PRELIMINARY SITE PLANS

3420 ROCHESTER ROAD

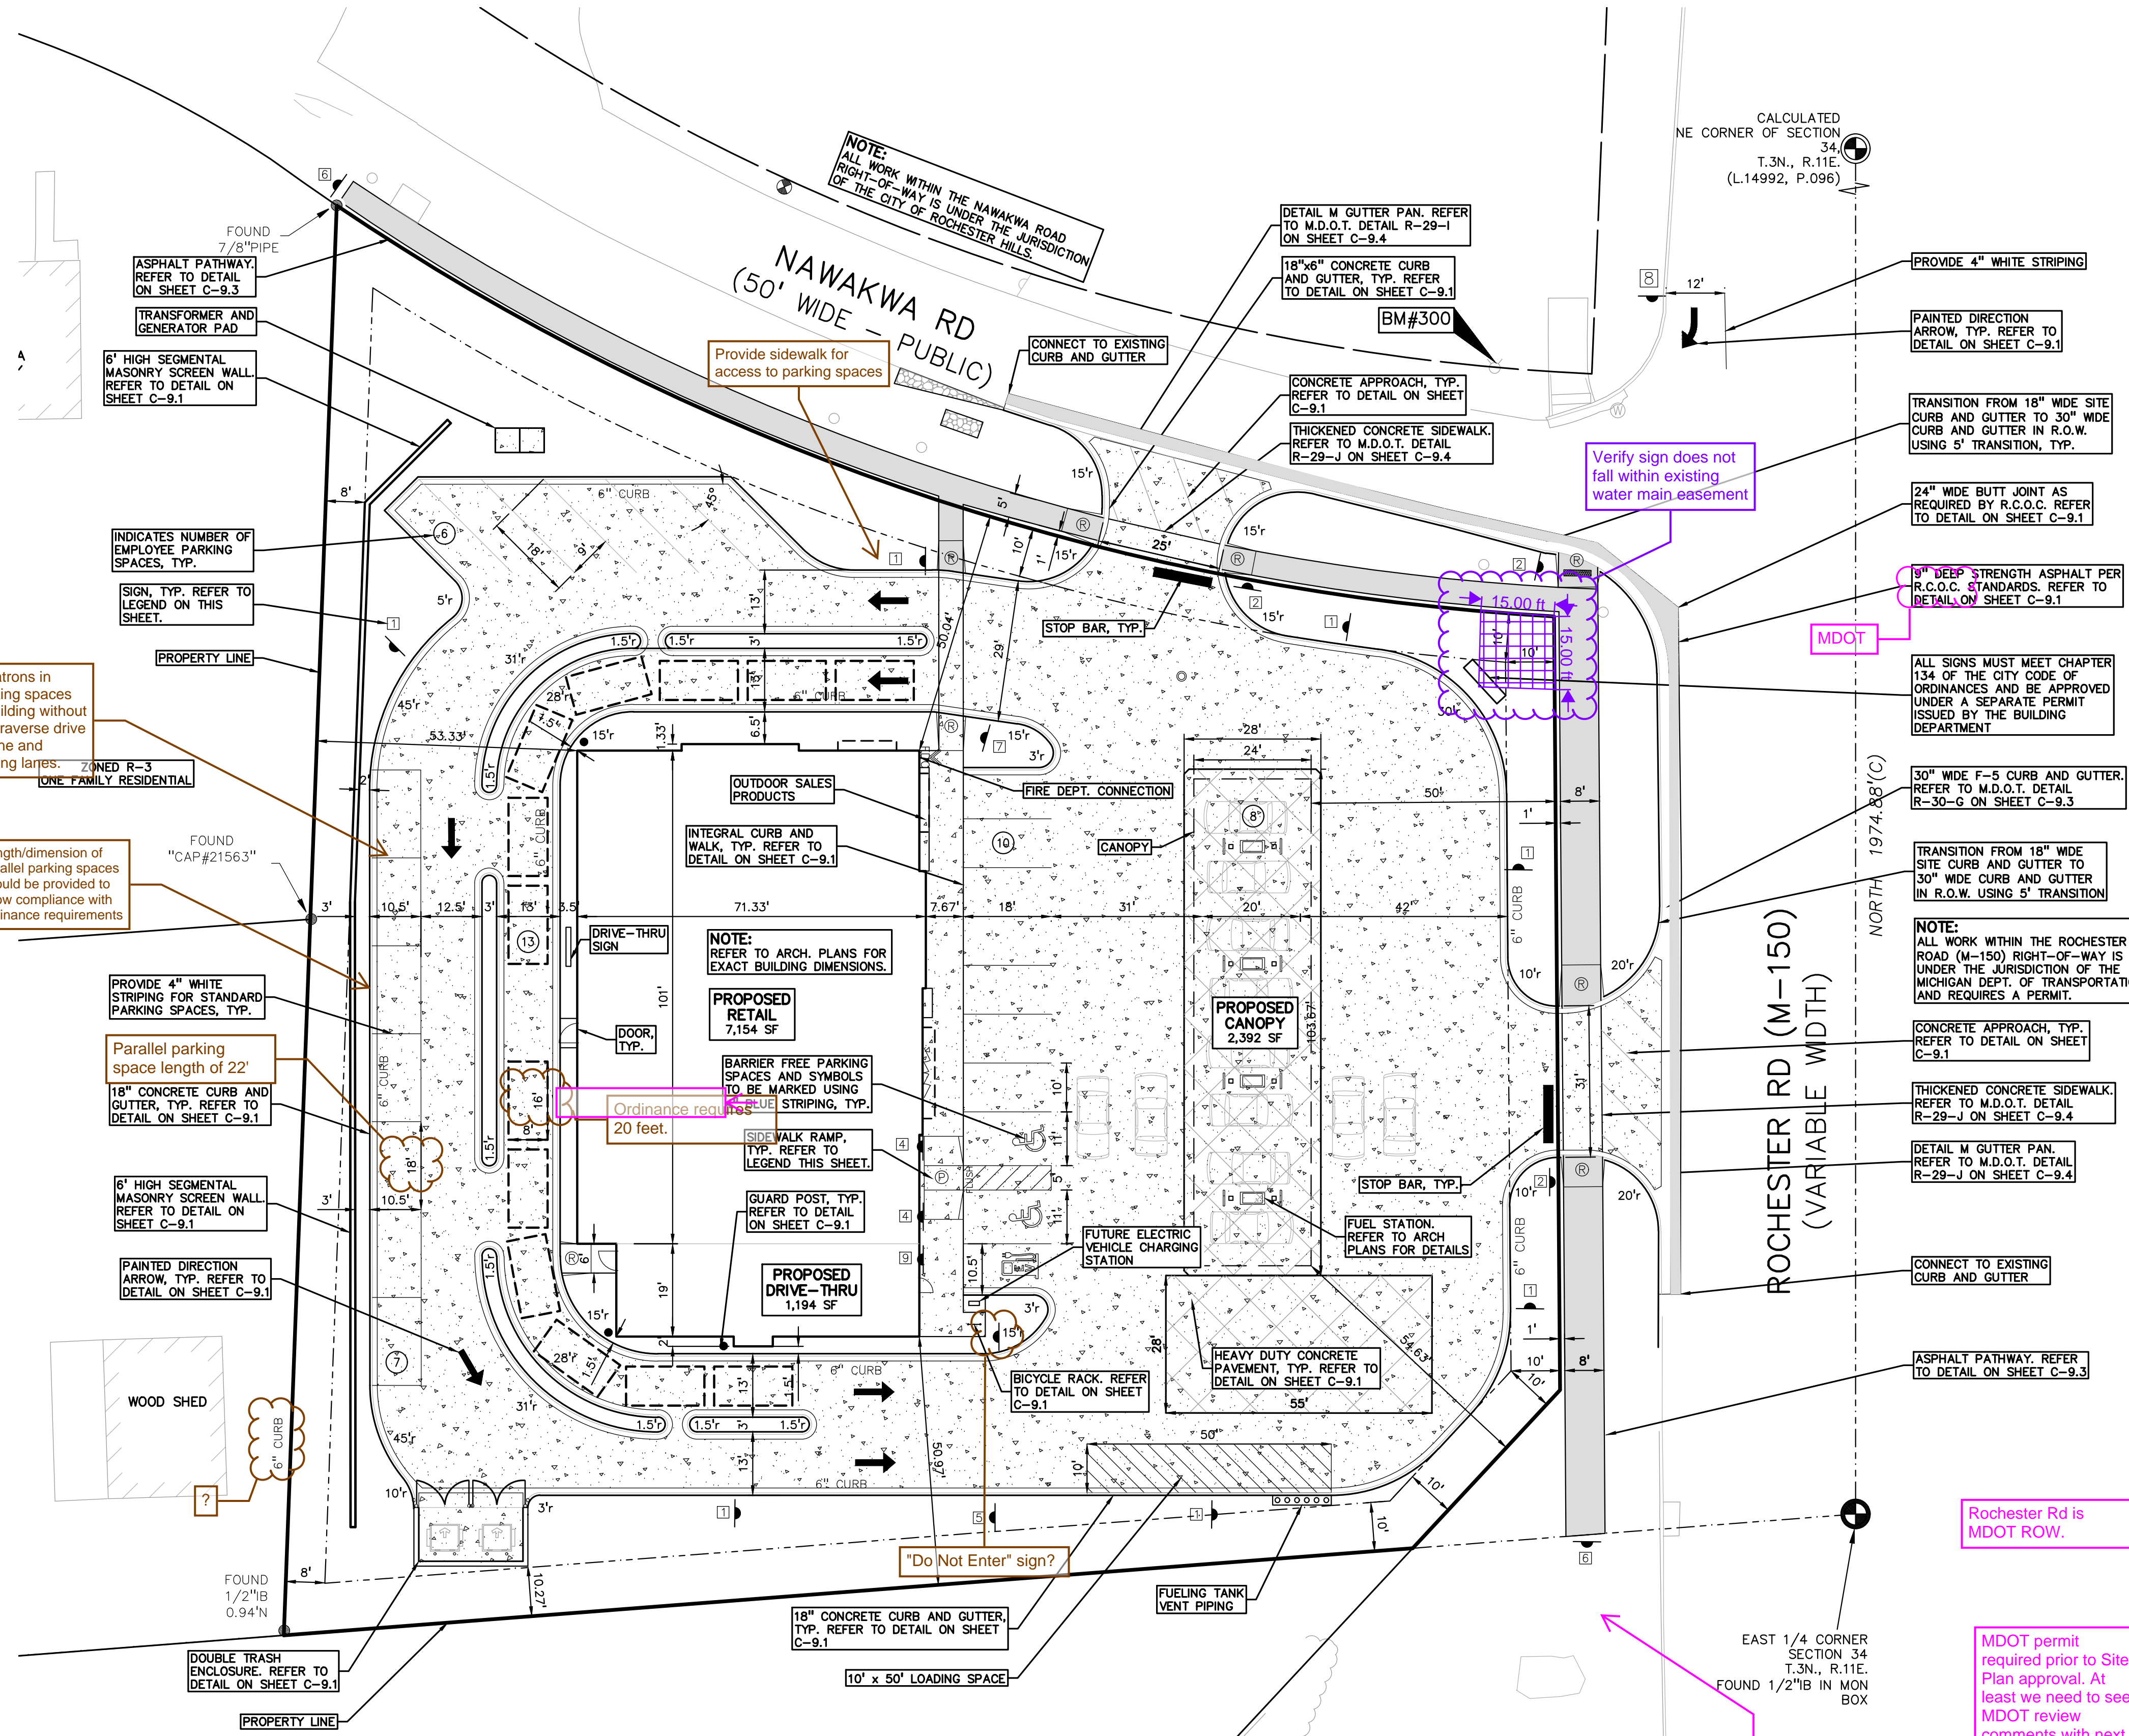
MDOT permit required prior to Site Plan approval. At least we need to see MDOT review comments with next review.

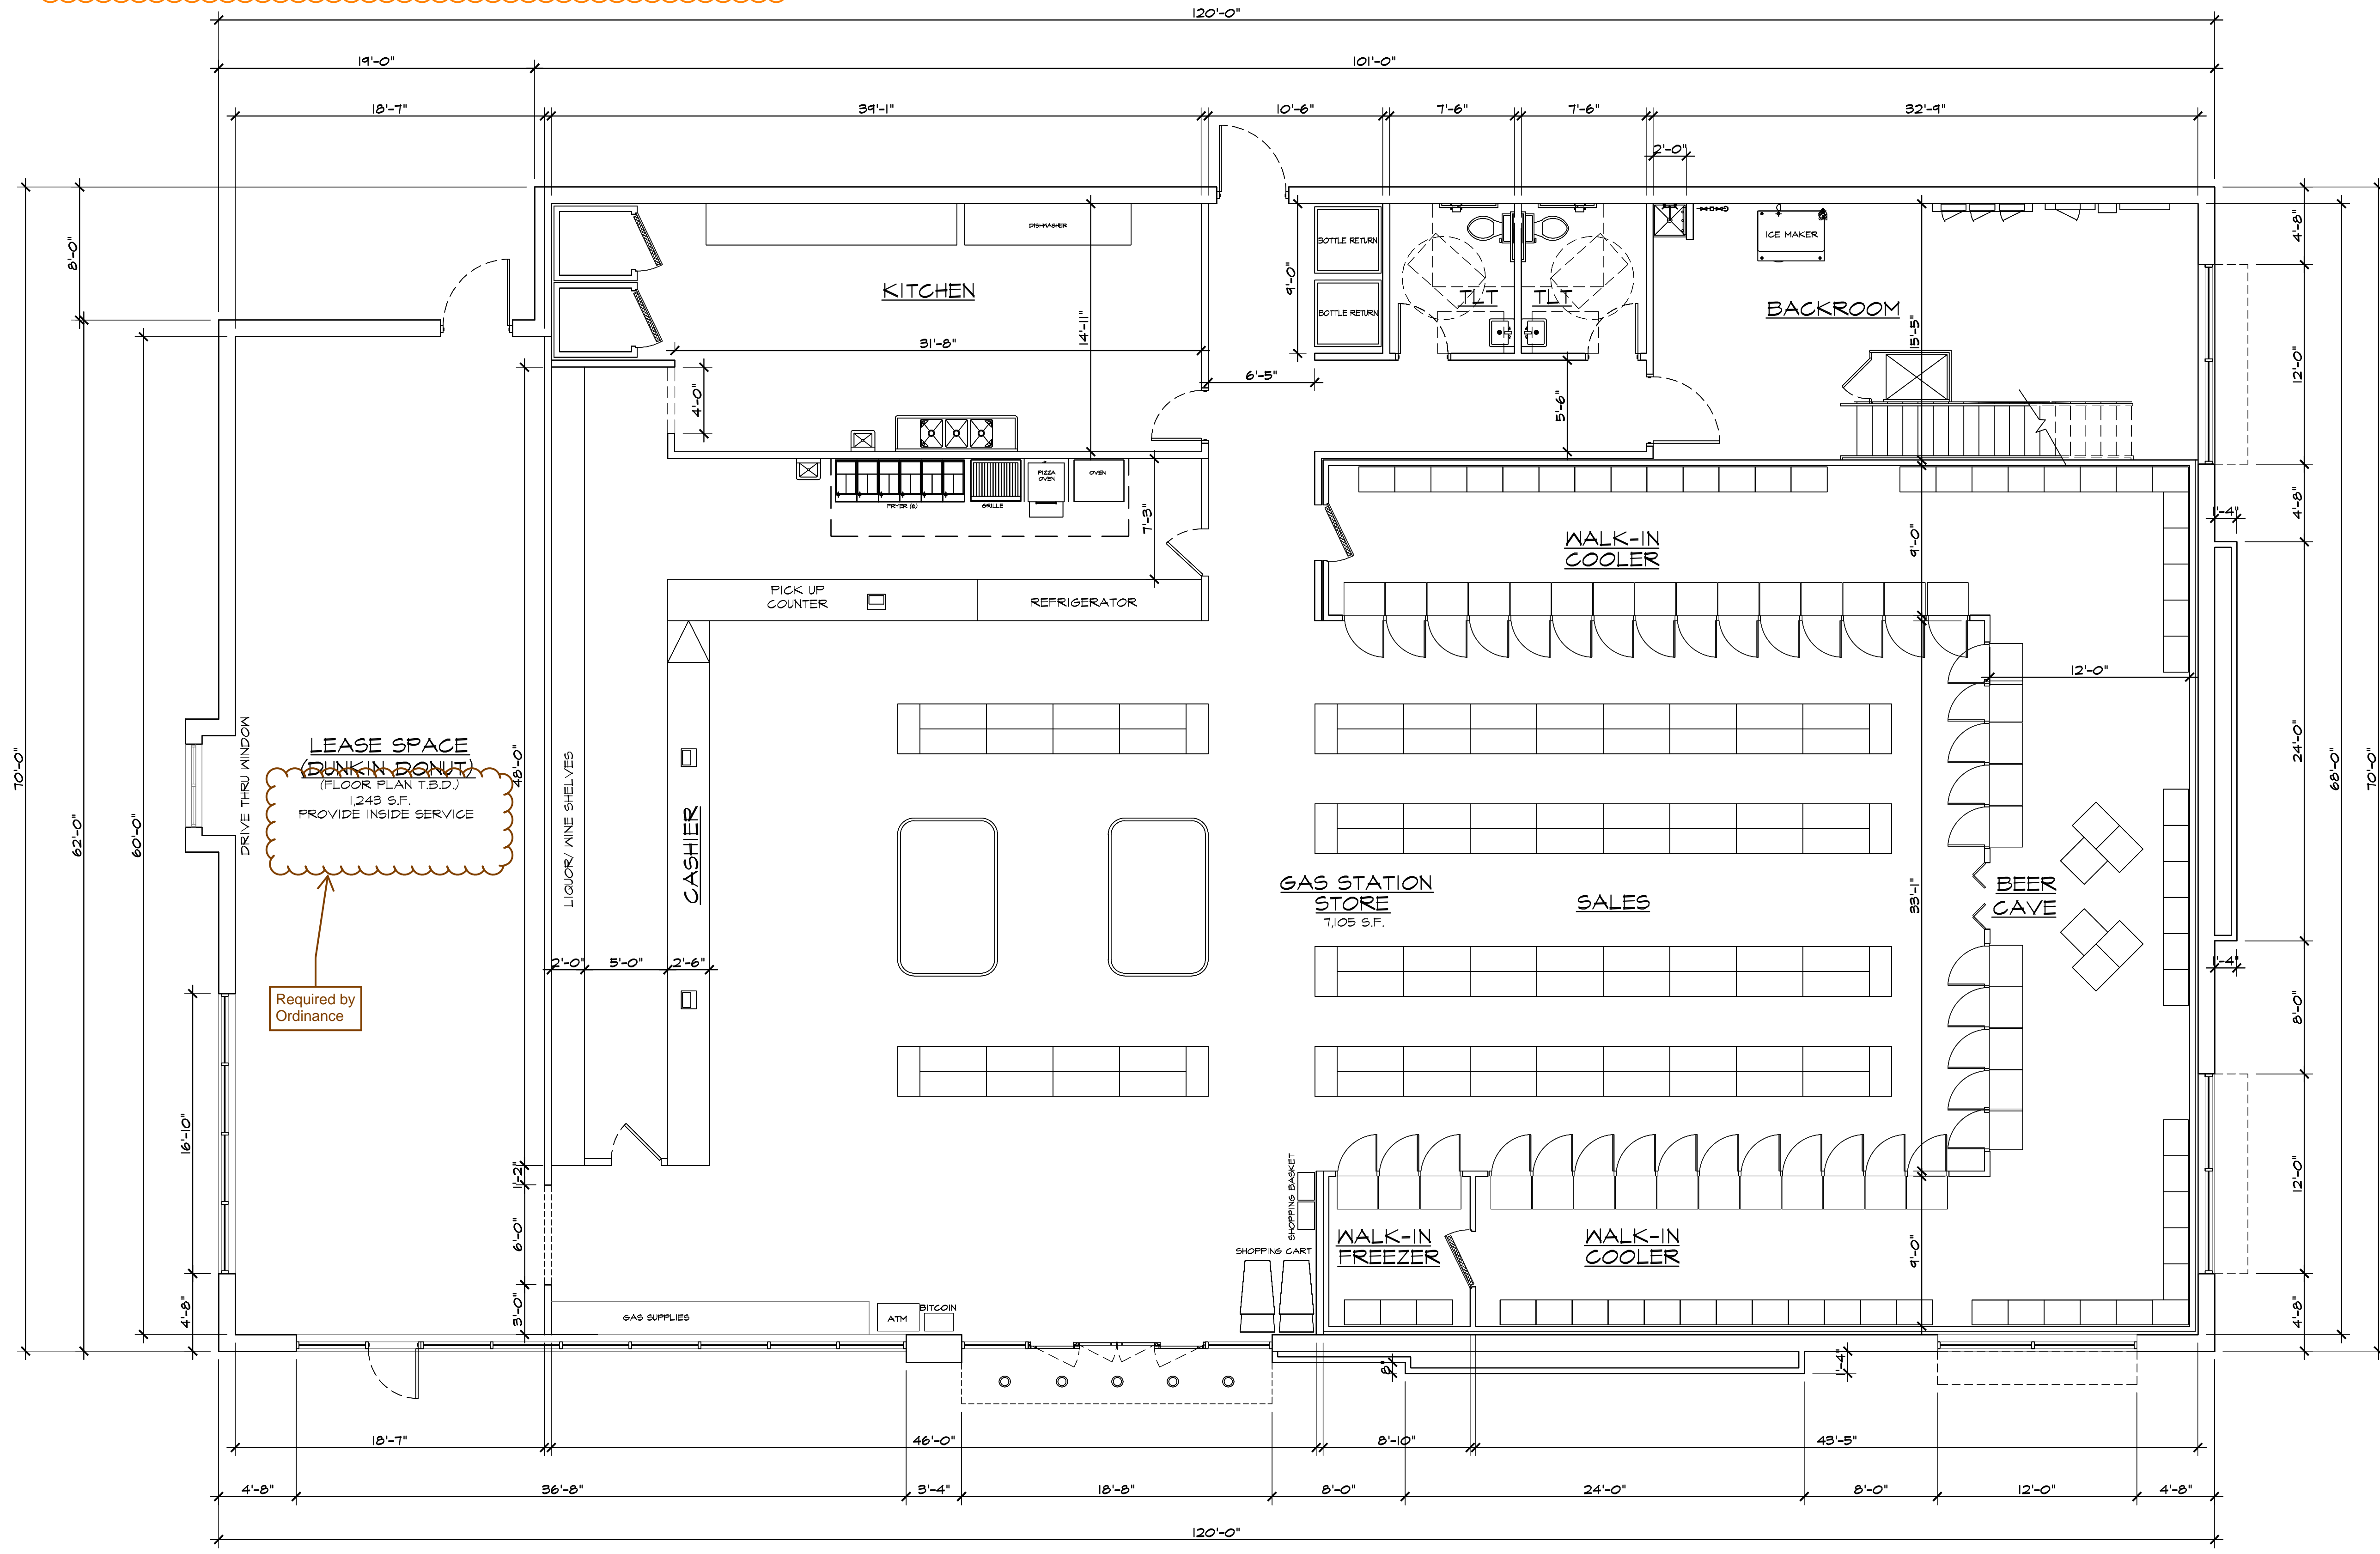
Please address the highlighted items circled in red on the attached "Commercial Site Plan Review Checklist".
